**ADDENDUM NO. 3**

March 4, 2016

**Re: Sanford High School and Technical Center  
12-067-00**

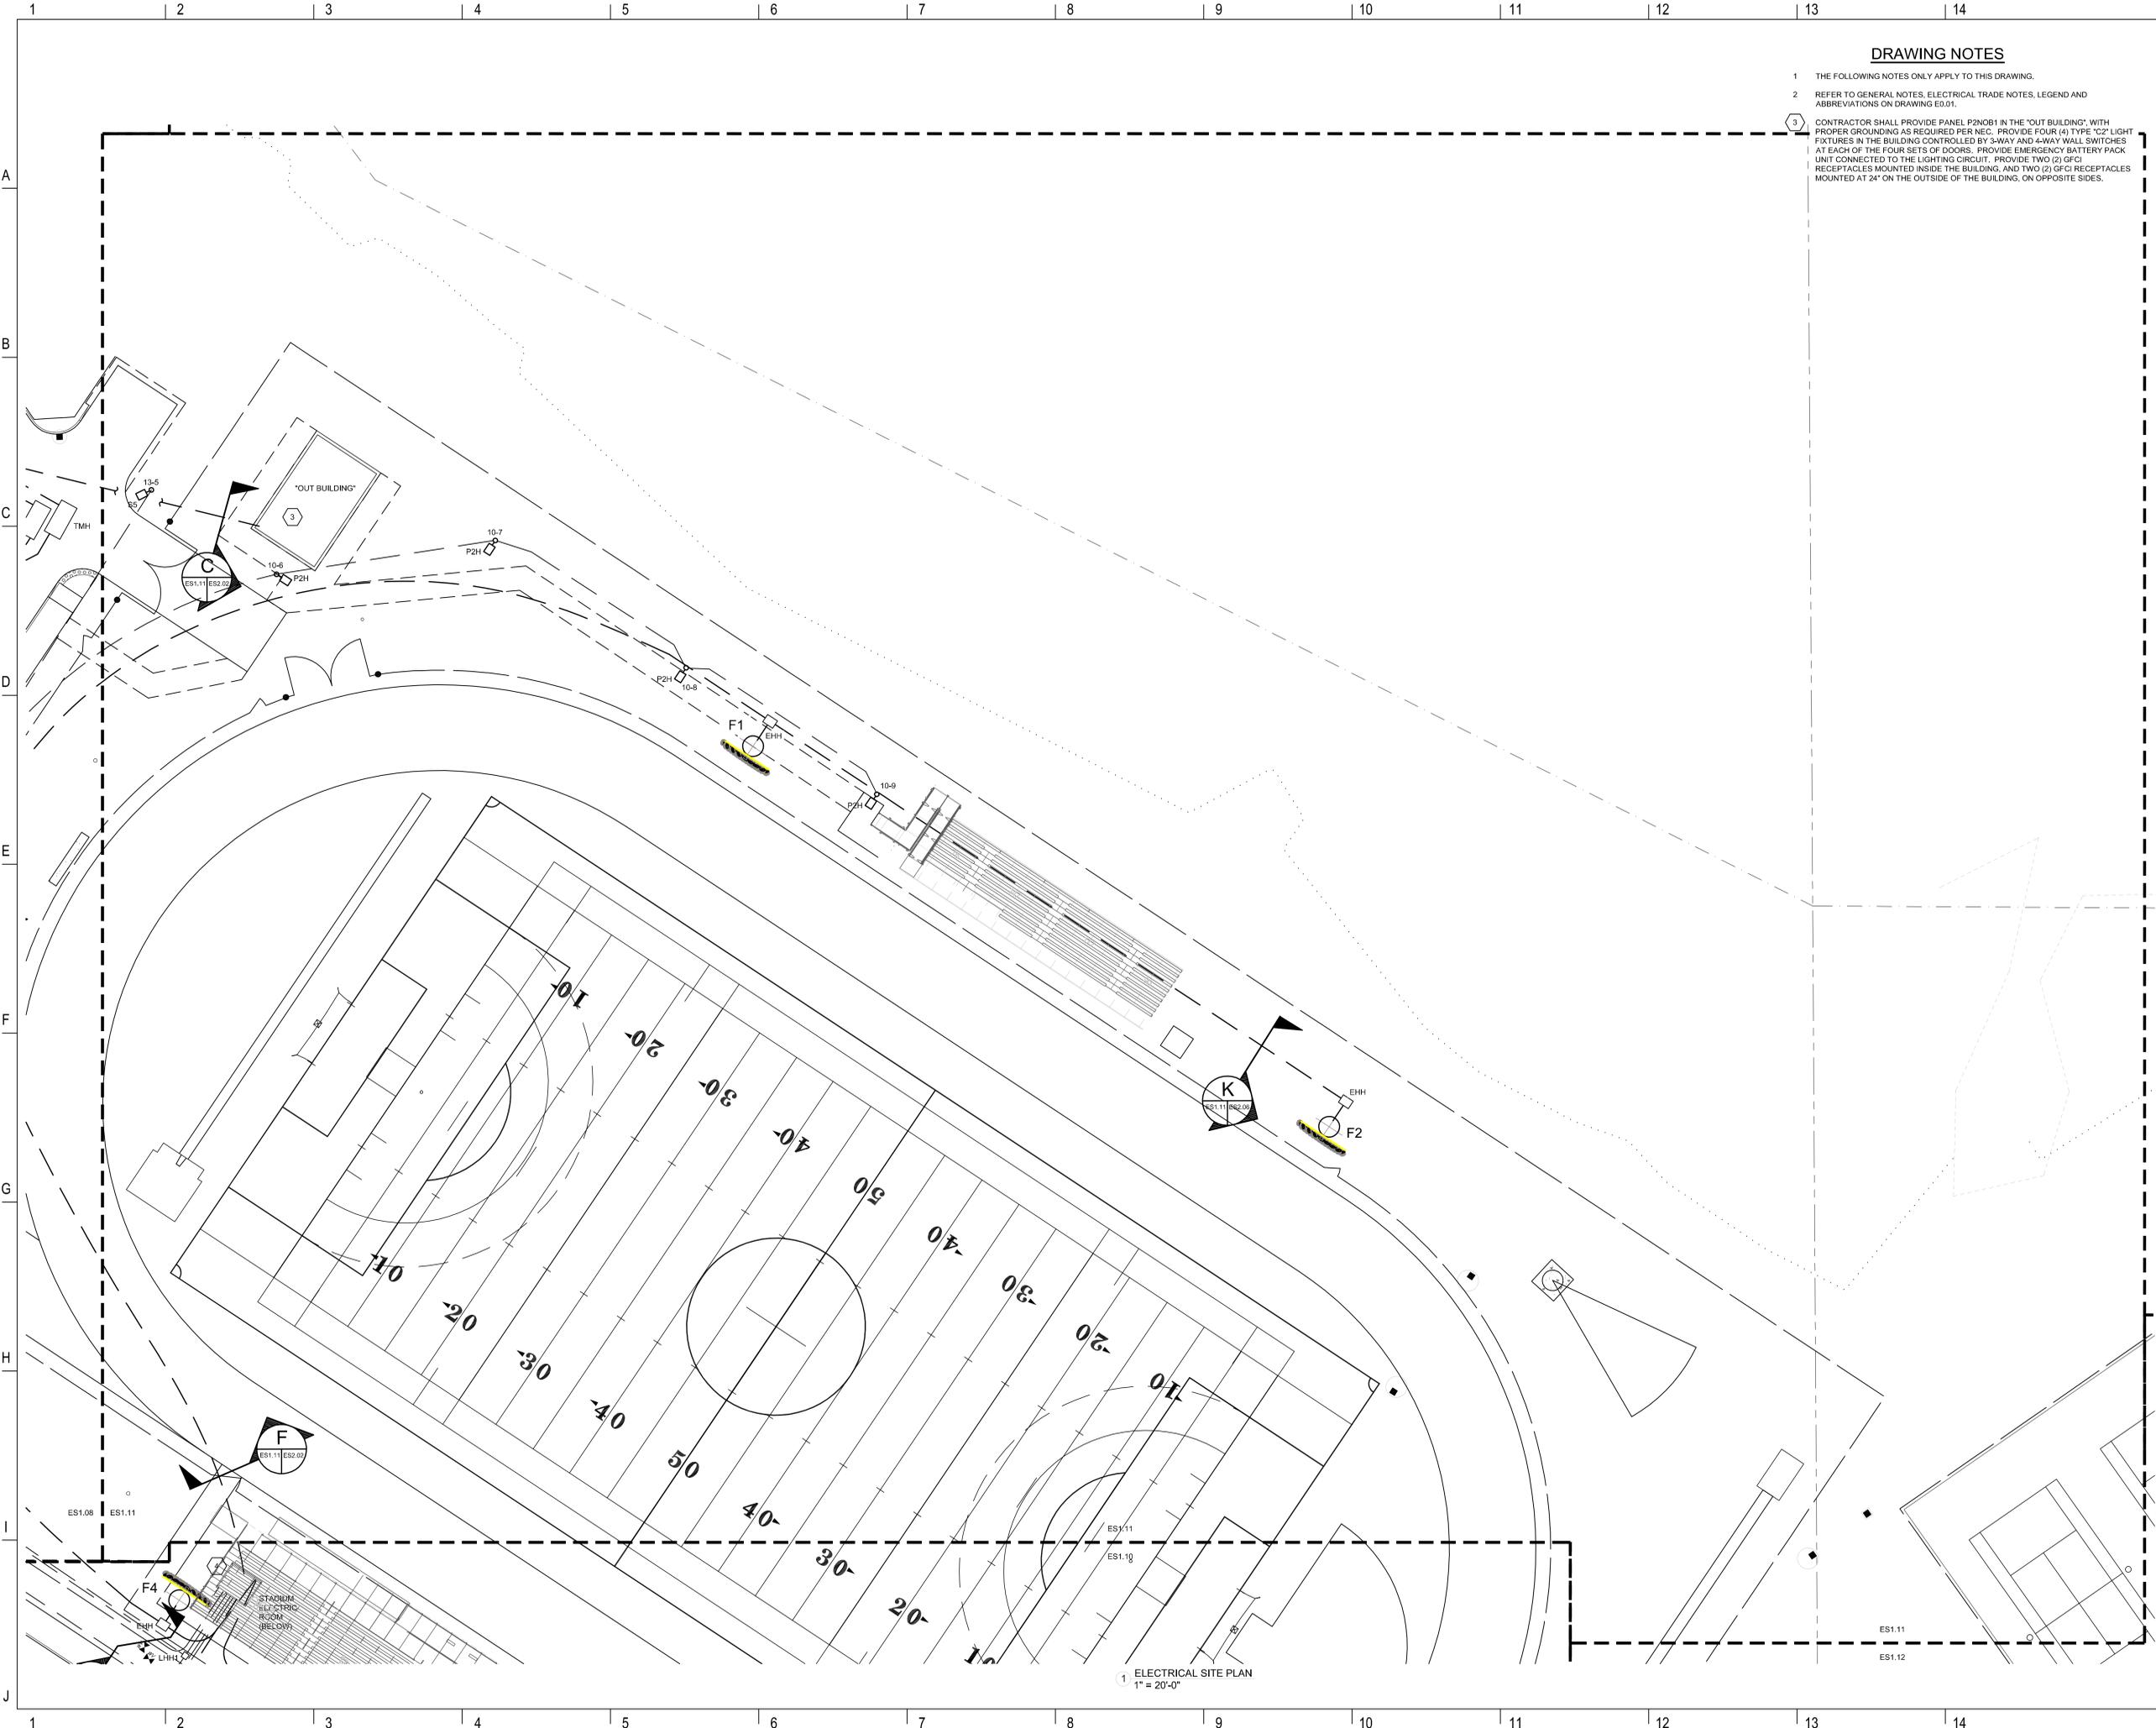
**Item No. 3.49 Reference Electrical Drawings** Question: Blue Phone spec indicates that 120V is required. ES2.04 shows a 120 duplex receptacle in the pole mounted box for the media converter. None of the ES dwgs indicate providing 120V power to either the site phones or camera locations. Please modify the ES dwgs to include conduit and wiring (size and source) as required. There appears to be a conduit from CHH1 running to E127B in ES1.08; Is this for 120V to this Blue Phone and S4C?

Answer: See attached Drawings. Should read THH1 in lieu of CHH1. This is for fiber optic cabling. Power for blue light phones added to attached updated drawings (ES1.08, 1.10).

**ES2.02**

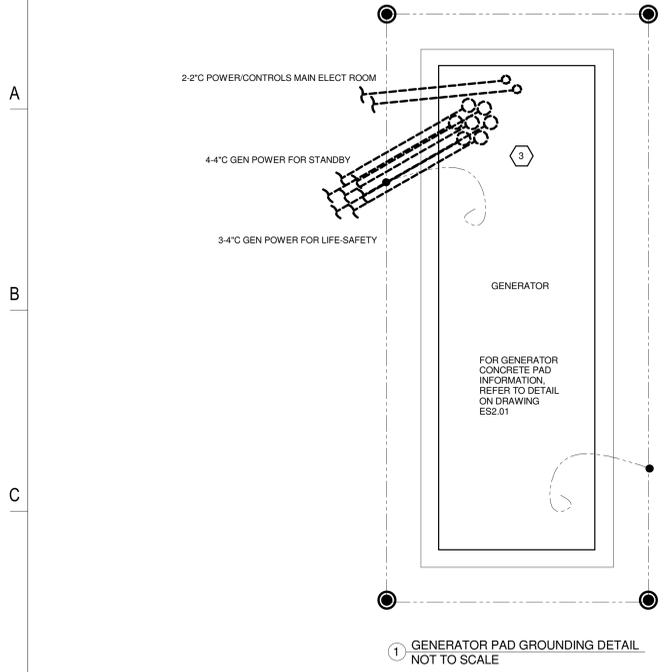
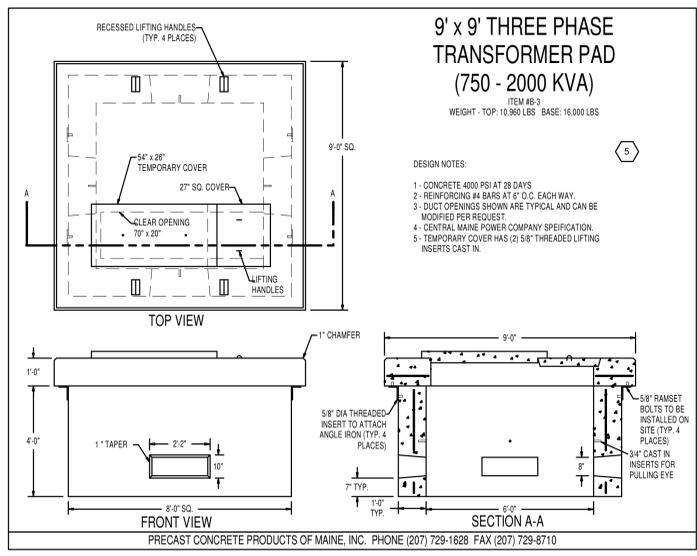
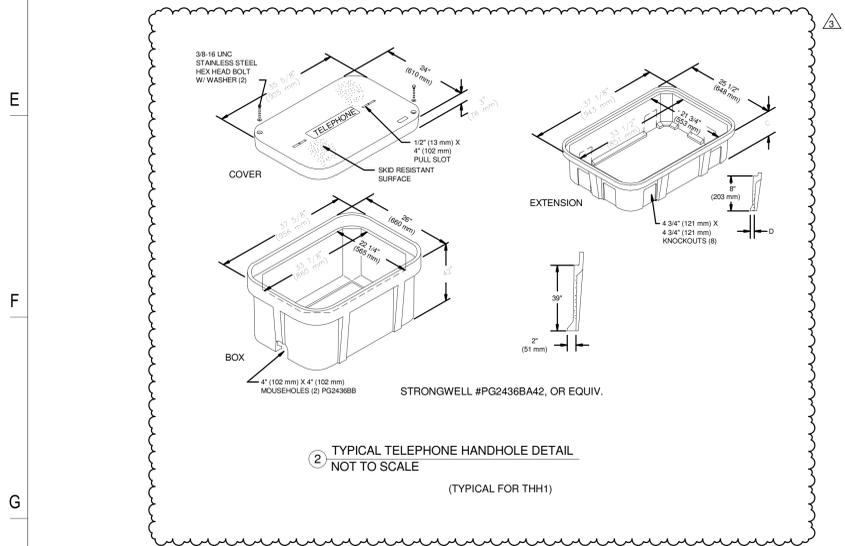
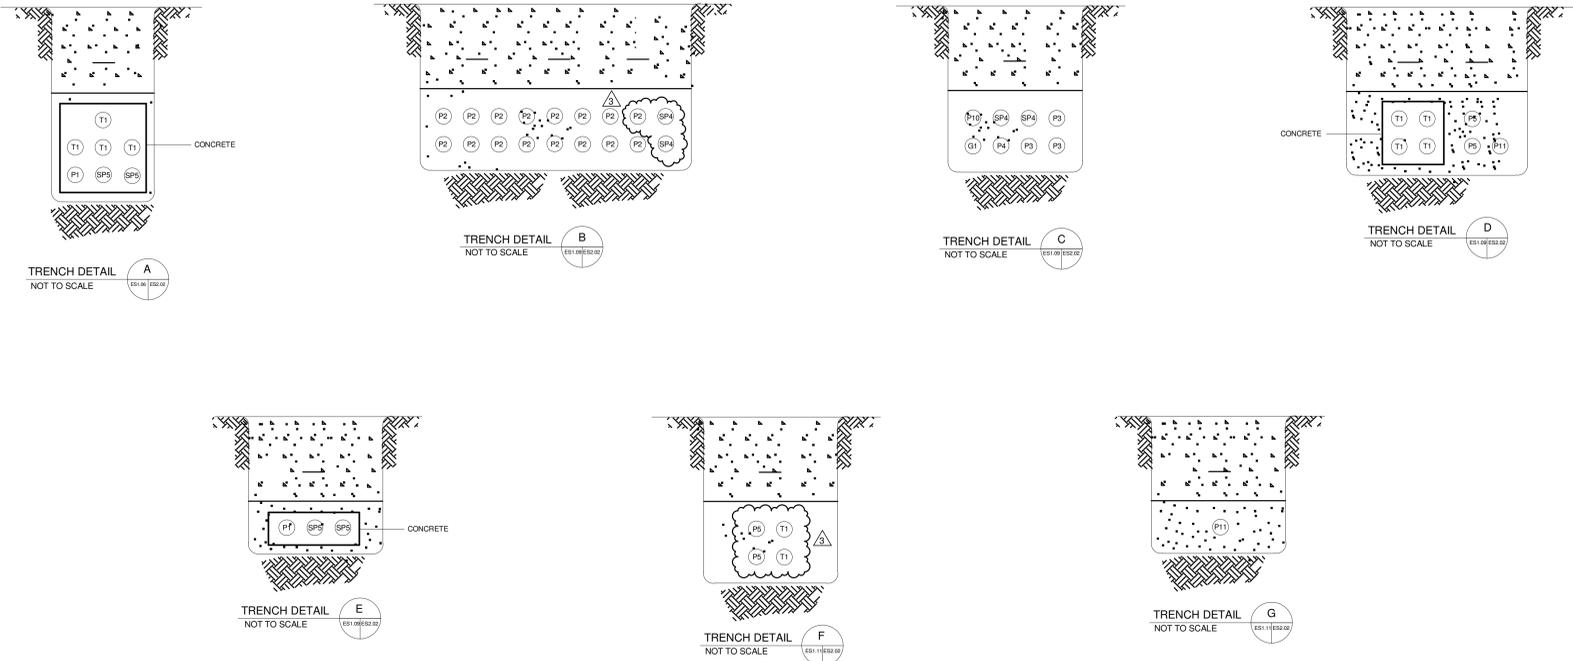
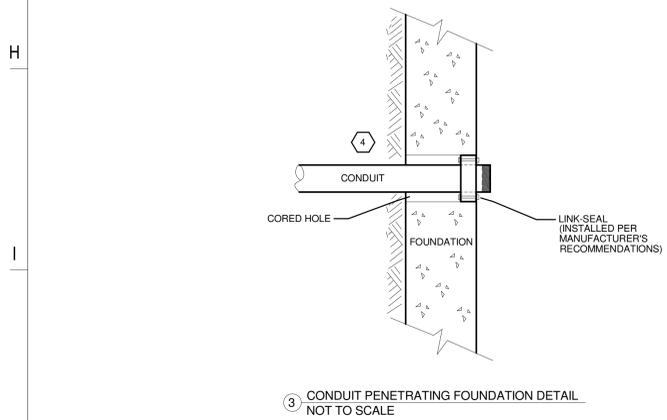
**Item No. 3.43 Reference Drawings ES2.01, 2.02** Question: The 1-line indicates 8 sets of 4-#500 in 4”C + 1 spare. ES2.01 indicates P2 as 4”C w 4-#600. ES2.02 indicates trench B as 15x P2 + 2 spares. Please confirm that 8 sets + 1 spare is desired for each service? Please advise if #500 or #600 is required for the service?

**Item No. 3.44 Reference Drawing ES2.02** Question: There is clearly intent to have site and stadium cameras as well as press box communications run to the stadium electrical building. Trench detail F on ES2.02 does not contain a communication conduit. Please advise as to how, or modify ES dwgs, to provide for a backbone pathway from the school to the stadium electric room. Answer: Trench detail was updated – drawing attached.

Answer: The one-line is correct; 8 sets of 4-#500 in 4”C + 1 spare. Drawings ES2.01 and ES2.02 have been updated and are attached.

**S1.5**

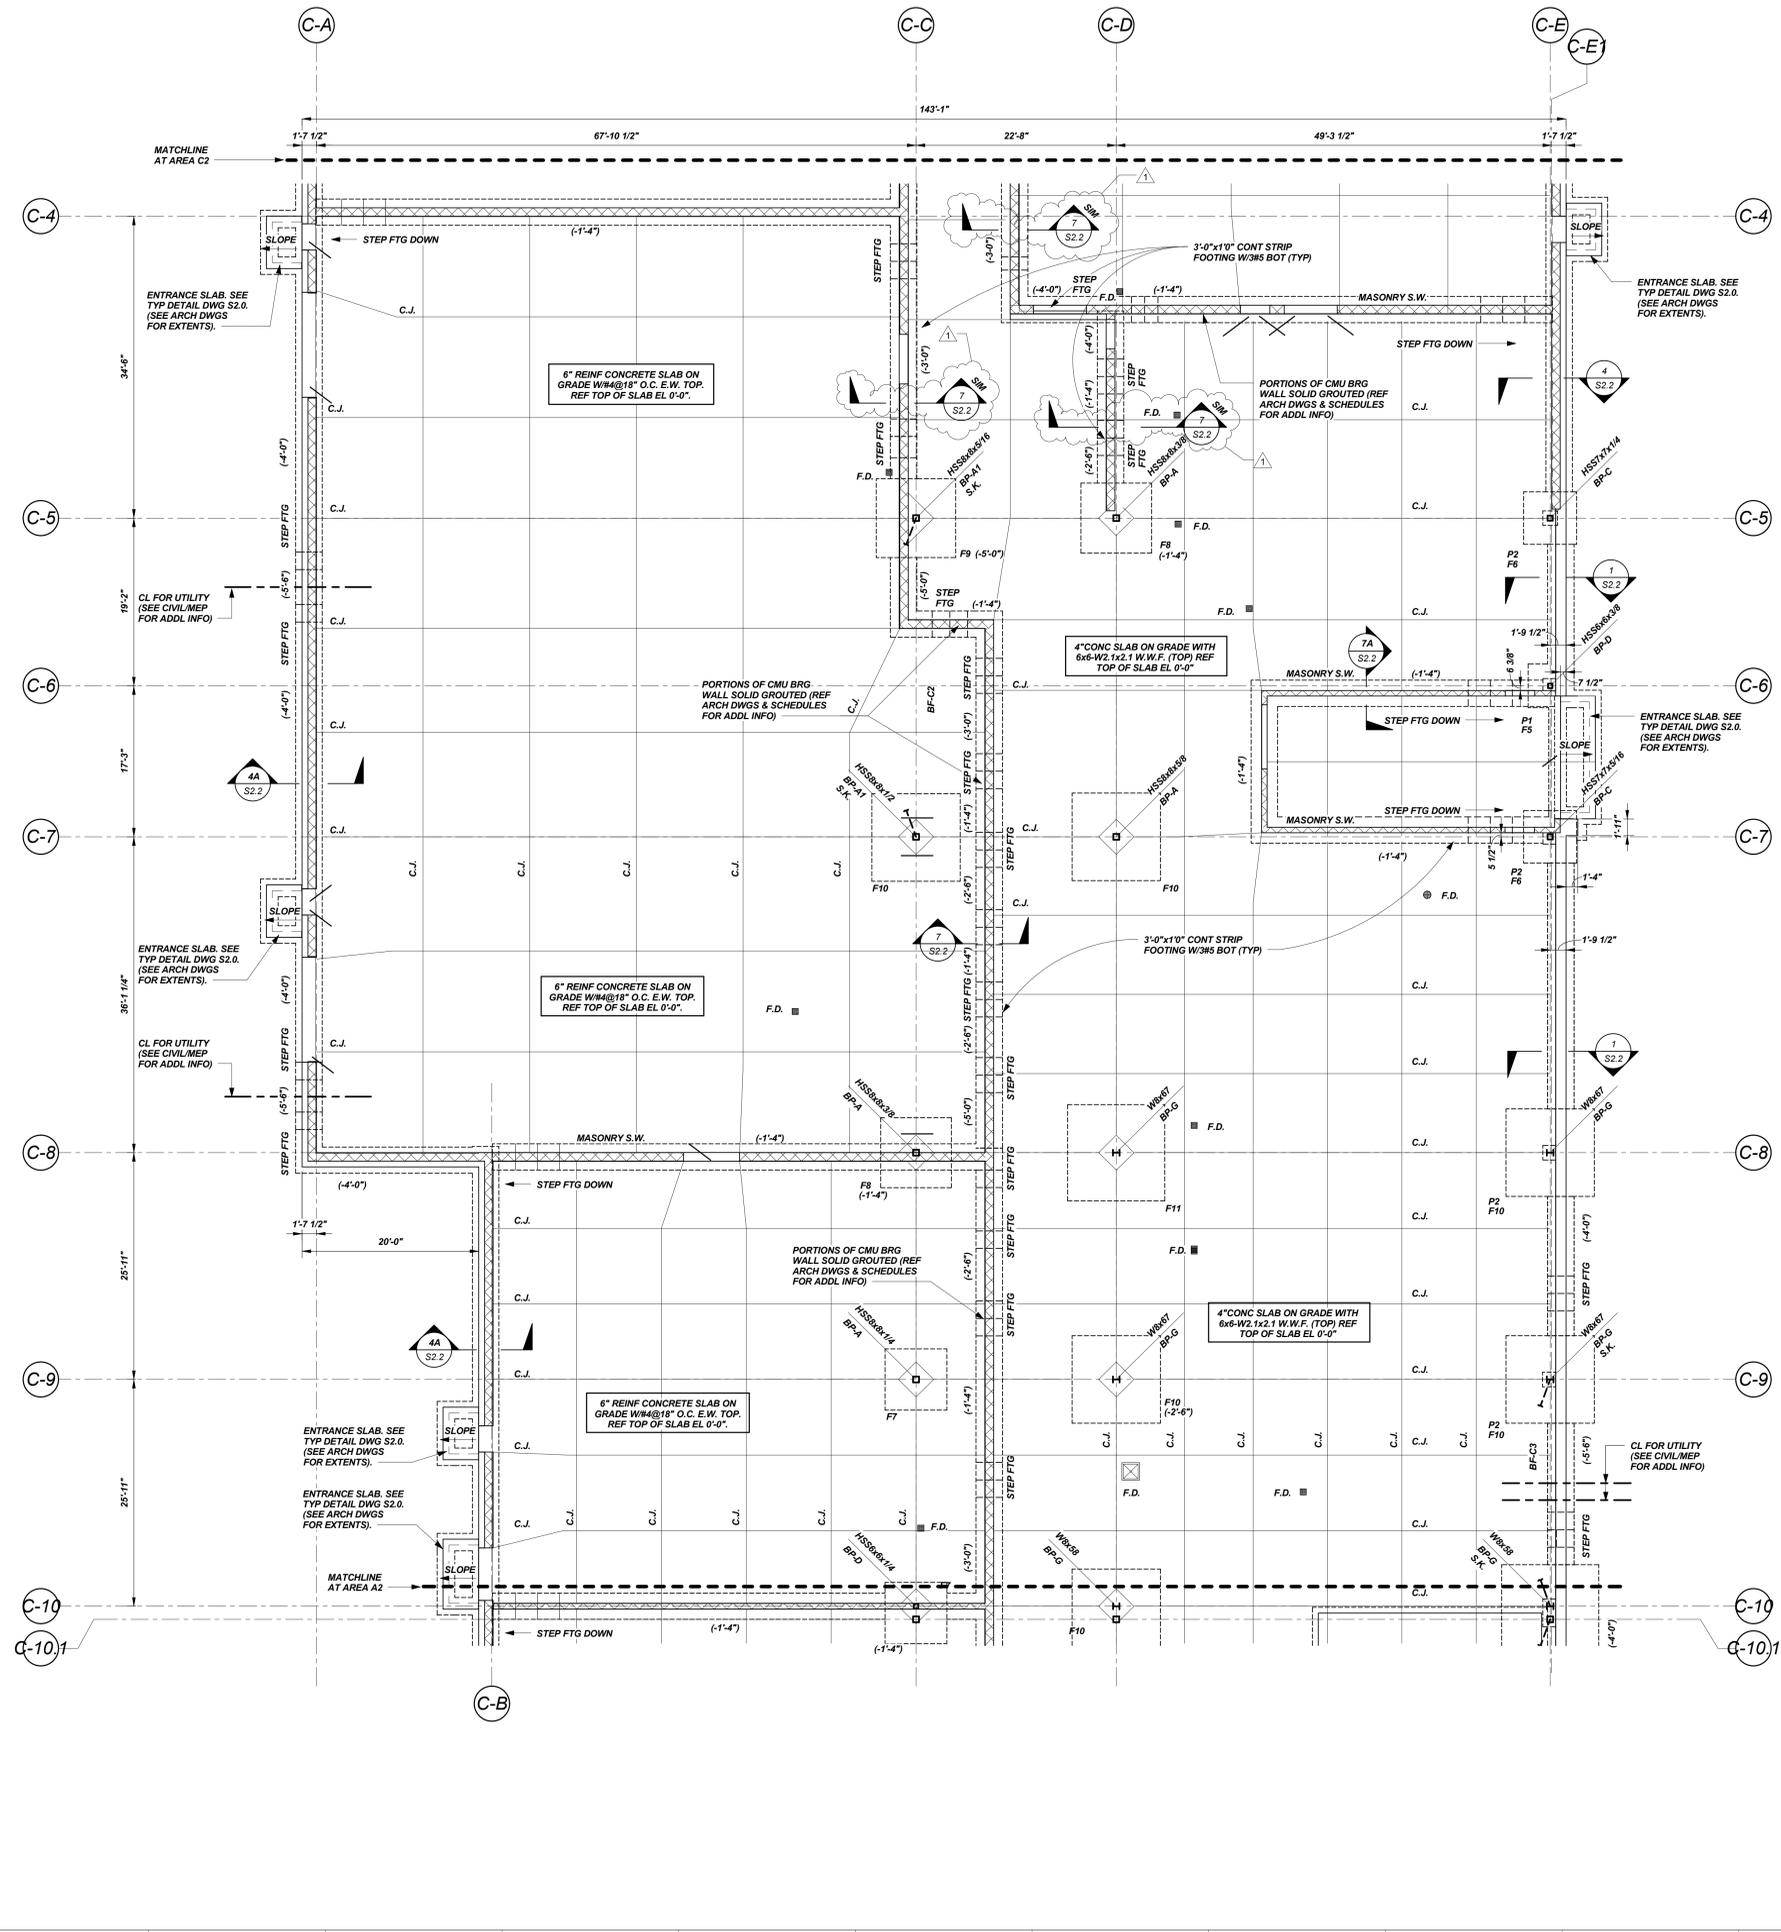
**Item No. 3.59** Reference Drawing S1.6, S1.3, S1.5, S1.9. Question: Line CE-1 from line C-1 to match line shows both sections 4/S2.2 & 4A/S2.2. Please verify.

Answer: Attached drawings S1.3, S1.5, S1.6 & S1.9 clarify this section and other foundation sections in certain locations. Rammed Aggregate Pier loads are clarified on S1.9. Note 4A/S2.2 specifies a 4 foot wide footing. Note 7 "Sim"/S2.2 specifies a 4 foot wide footing.
